1997 - 1999 Corvette: Service Bulletin: Chime Sounds When Key is Removed from Ignition

Subject: Chime Sounds When Key is Removed from Ignition, Intermittent Operation of Power Door Locks, Keyless Entry, Steering Column Lock or Memory Seats (Inspect/Replace Lock Cylinder Actuator or Lock Cylinder Assembly)

Number: 99-08-49-008

Actuator Type Identification

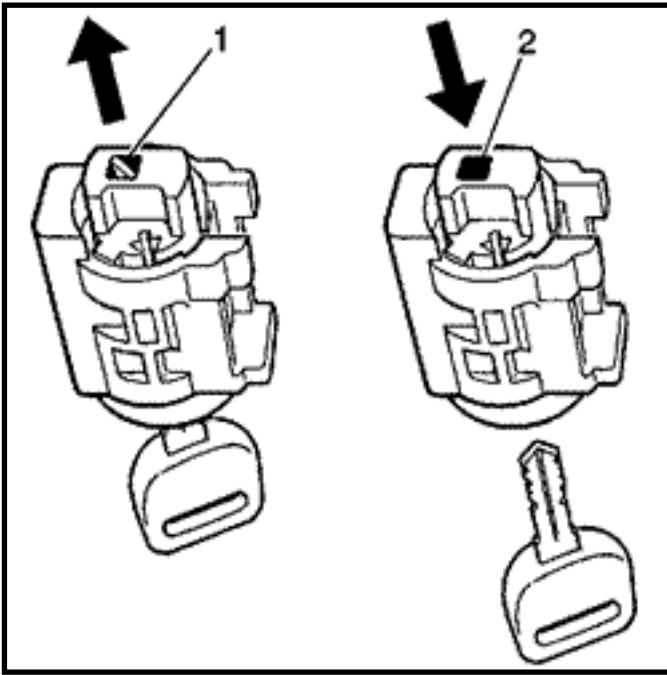
- (1) Early Design Actuator in the Lock Cylinder
- (2) Side View of the Early Design Actuator When Removed from the Lock Cylinder
- (3) New Design Actuator in the Lock Cylinder
- (4) Side View of the New Design Actuator When Removed from the Lock Cylinder

With the key installed, hold the lock cylinder as shown in Figure 2 to determine what type of actuator is being used. FOLLOW THE APPROPRIATE TEST PROCEDURE FOR THE TYPE OF ACTUATOR BEING USED.

1. With the lock cylinder held vertically as shown in Figure 3, remove the key from the lock. When the key is removed, the actuator should drop down in the lock cylinder approximately 4-5 mm (3/16 in). Repeat this step several times.
2. If the **EARLY** design actuator in the lock cylinder does **NOT** drop down, replace the complete lock assembly.
3. If the **EARLY** design actuator in the lock cylinder **DOES** drop down, replace the actuator with the new design actuator P/N 12450483.
